SEMINOLE TRIBE OF FLORIDA

RFP 37-2025 WEST BOUNDARY ROAD (384023) (BIG CYPRESS)

Addendum No. 3, Date issued August 5, 2025

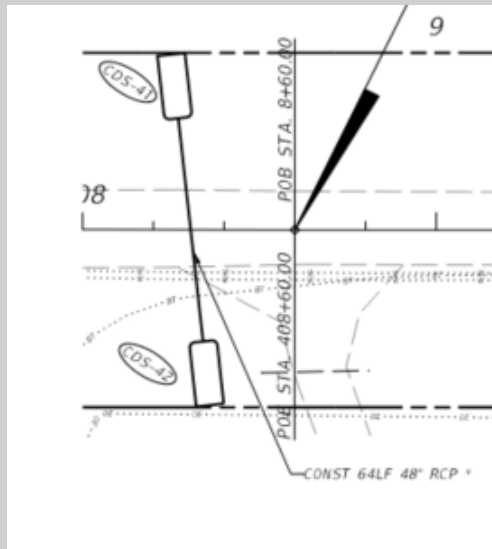
| <p>9. Q: Casings shown to be installed via directional drilling are almost all too short and flat to be installed via directional drilling. Is jack and bore an acceptable method to install these casings?</p> | | |

| | <u>A:</u> Please refer to the TRIBE’s response to Question #8. |

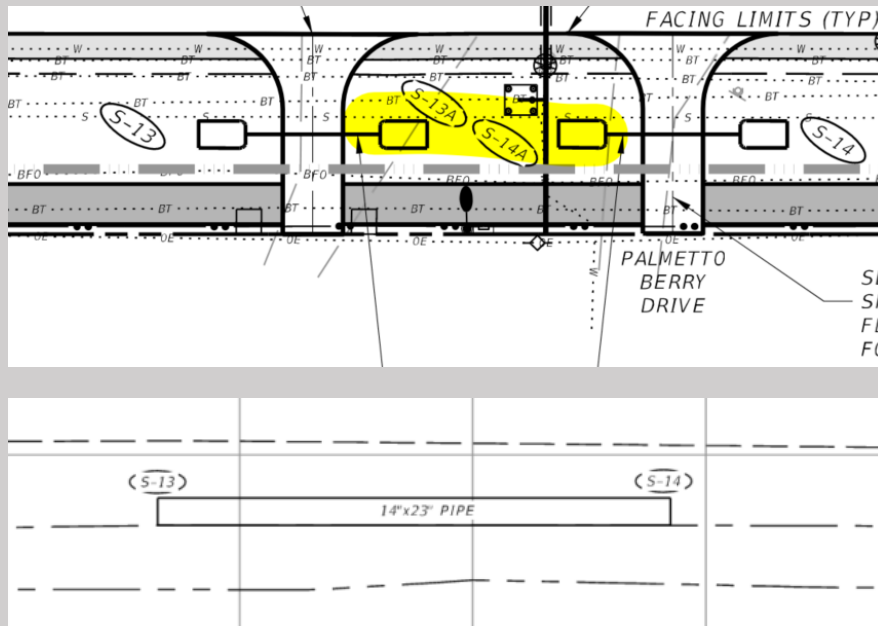
14. Q: In *Attachment A – Plans*, on Sheet No. R-9, (image below) CDS-41 and CDS-42 and the 64LF of 48" RCP connecting them are not shown on the profile view of Sheet No. R-9 nor are they shown on the Drainage Structure plans (Sheets No. R-61 to R-63). It is requested this information be added for potential bidders to know the elevations for excavation/backfill and installation purposes. Also, potential bidders need to know how the road and ground above this drainage run is to be restored and paid.

A: The above referenced image shows a replacement of an existing cross-drain to be installed at the same horizontal and vertical locations as the existing pipe. Bidders may visit the project site to confirm existing conditions.

Please see the revised *Attachment A – Plans REV001* and *Exhibit A – Proposal Form REV001* released through this Addendum No. 3 which include the work associated with this item as Alternate #4.
